UNITED STATES PATENT AND TRADEMARK OFFICE

APPLICATION NO.	FILING DATE	FIRST NAMED INVENTOR	ATTORNEY DOCKET NO.	CONFIRMATION NO.
10/562,681	08/21/2006	Robert Yaw Gyamfi Andoh	P08829US00/MP	4066
881 7590 06/08/2009 STITES & HARBISON PLLC 1199 NORTH FAIRFAX STREET SUITE 900 ALEXANDRIA, VA 22314			EXAMINER MELLON, DAVID C	
			ART UNIT 1797	PAPER NUMBER
			MAIL DATE 06/08/2009	DELIVERY MODE PAPER

Office Action Summary

DETAILED ACTION

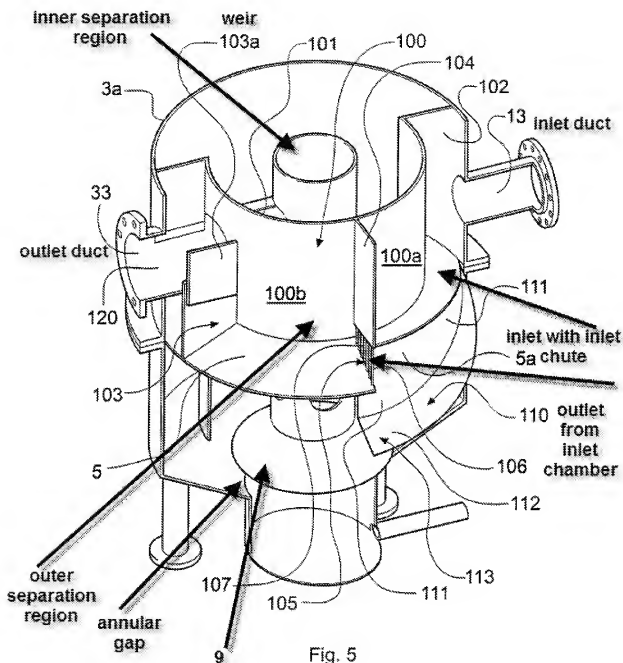
Regarding claims 1-2, Andoh et al. discloses a hydrodynamic separator for separating material from a liquid (abstract) in figures 1, 4-6 comprising:

- A vessel (2) having a cylindrical outer wall (3)

- An inner partition (chamber – 31)
- An inlet (13) opening into the outer separation region (see annotated figure 5)
- An outlet (33) opening into the inner separation region (see annotated figure 5)
- A frustoconical base (4) which converges to a downward outlet opening (8) which outlet opening (8a) communicates with the outer separation region beneath the inner partition (clearly shown in fluid communication)
- Wherein the inner separation region is annular (it is round and thus annular) and is closed at a lower end thereof (P12/L18-22 - "the conical member 9 may be solid" which would imply that it would close a portion of all of a lower end of the inner separation region).

Regarding claims 4 and 5, Andoh et al. further discloses the inner separation region communicates with the outer separation region through at least one aperture formed in the inner partition (openings 11 or also interpreted as opening at 9) shown adjacent the lower end of the inner partition.

Regarding claim 7, Andoh et al. further discloses the aperture comprises a circumferential gap between the inner partition and a wall closing the lower end of the inner partition (gap between 9 and wall 4).

Regarding claims 9-11, Andoh et al. further discloses the inner separation region is closed at its lower end by a downwards diverging, extending beyond the partition wall (9 – frustoconical base member, shown diverging downwards extending beyond partition 31, see also P12/L18-21 – “solid”).

Regarding claim 12, Andoh et al. further discloses that the wall (9) terminates short of the frustoconical base of the vessel, creating a gap between the base and the wall (see annotated figure 5).

Regarding claims 16 and 17, Andoh et al. further discloses an outlet duct that extends from the liquid outlet through the outer wall of the vessel and is inline with the

inlet duct which extends through the outer wall (see annotated figure 5, inlet and outlet 13 and 33 extending through vessel wall and inline with one another).

Regarding claim 18, Andoh et al. further discloses an inlet disposed below the inlet duct (see annotated figure 5) with an inlet port to discharge inlet flow into the vessel in a tangential direction to the cylindrical outer wall (inlet chute is wrapped around the cylindrical wall).

Regarding claim 19, Andoh et al. further discloses that the inlet and outlet ducts are disposed at an upper region of the vessel (see figure 5).

Regarding claims 23 and 24, Andoh et al. further discloses that the inner partition (31) is cylindrical (shown in annotated figure 5) and that the inner partition is coaxial with the outer wall (see figure 4).
